Camden Council

Ordinary Council Meeting
11 October 2016

SUBJECT: CONSTRUCTION OF A TWO STOREY DWELLING AND ASSOCIATED SITE WORKS - 17 ALLISON CIRCUIT, ORAN PARK

SUBJECT: CONSTRUCTION OF A TWO STOREY DETACHED DUAL OCCUPANCY AND STRATA SUBDIVISION - 36 RADISICH LOOP, ORAN PARK

DCP Variation 1 – Driveway Location to be paired

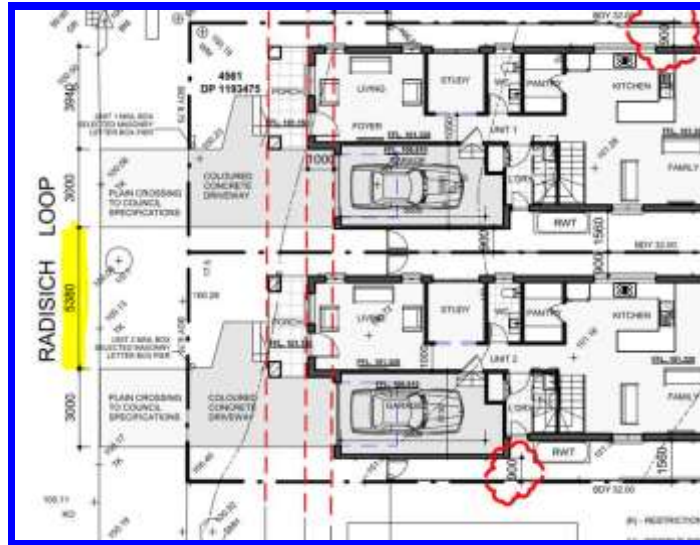
The proposed driveways to service each dwelling are separated and are not paired. The arrangement of the driveway can be seen in the figure below.

2. *Table 17 'Summary of key controls for lots with frontage width $\geq 7m$ and $< 9m$ for front accessed dwellings' within the Oran Park DCP requires driveways to be provided in a paired configuration to preserve on street parking. The proposed driveways are not paired.*

Council officers have considered the variation to the DCP and recommend that it be supported in this instance for the following reasons:

- The proposed location of the driveways will not result in an additional loss of on street parking in front of the lot. Should a paired configuration be considered, one space would be provided to the south of the driveway for Unit 2. As proposed, the driveways still enables an on street car space in front of the lot.

- The driveway arrangement has been reviewed by Council's traffic engineer with regards to the space required to park a vehicle on the street. The length of a standard vehicle is 5.2m long which includes most cars (including SUV's). The space between the driveways is 5.38m. As the driveways could be used to manoeuvre in and out of the space, it is acceptable that a large car could park in the 5.38m space. Therefore, the arrangement of the driveways provides for a parking space in front of the development.

- There is an existing street tree in the centre of the allotment which limits the location of the driveway. The proposed location of the driveways is considered a reasonable outcome to retain the street tree.

With the above considered, it is recommended that this DCP variation be supported.

A variation to the DCP is proposed as discussed previously in this report. A paired driveway is specified within the Oran Park DCP to maximise the amount of on street parking available. The proposed design provides a 5.38m on-street car space between the driveways, enabling sufficient room for a standard vehicle to be parked between the two driveways on the street. When compared to a paired driveway, the proposed driveway configuration will not result in a loss of on street parking as one parking space will be retained in front of the lot.
